MODIFICATION SHEET NO. RDSO/2008/EL/ MS/0360. (REV. '0')

Shifting of transformer conservators location from OCB duct to an independent stand provided in between SR & MR blower in 3-phase drive locomotives.

Conservator stand as per enclosed drawing No. SKEL-4730 Att'0'.

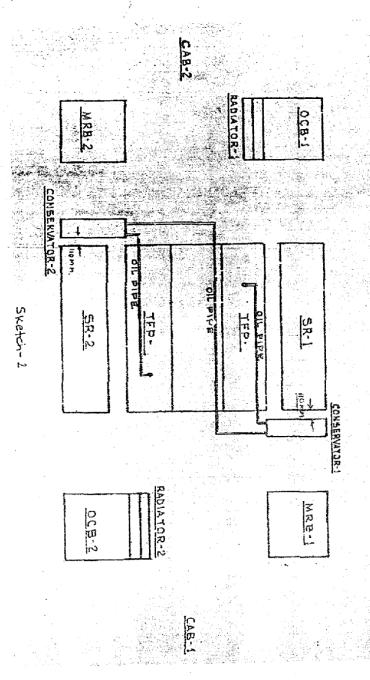
In the modified arrangement, the locations of both conservators are to be shifted each on an independent MS stand provided in between SR & MR blower. Following actions are required to be taken:

- Fabrications of MS stand as shown in the drg No. SKEL -4730 Alt'0'. Two MS stands are required for two-conservator tank.
- ii) Fixing of MS stands in between SR & MR Blower as given in Sketch-1 & 2 enclosed as Annexure-I & II. MS stand for conservator tank shall be provided 110 mm from the SR panel and its clearance from the corridor will be approx.65 mm. Clearance between conservator stand to side loco body wall is approx. 300 mm.
- iii) Mount the conservator tank on the stand. Tighten the MS flat at stand & SR panel as indicated in the section- A in the drawing No. SKEL-4730 Alt'0'.
- Mounting height of conservator tank shall be kept same as was in the original location.

Sketch-1

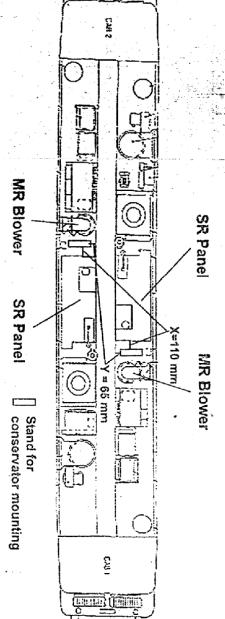
MODIFIED OIL CIRCUIT IN 3 PHASE LOCOMULIN

ls 110 mm.

Distance between SR-1,2 to conservator stand

body wall is approx. 300 mm.

3. Distance between long beam of corridor to conservator stand is 65 mm Distance between conservator stand to side
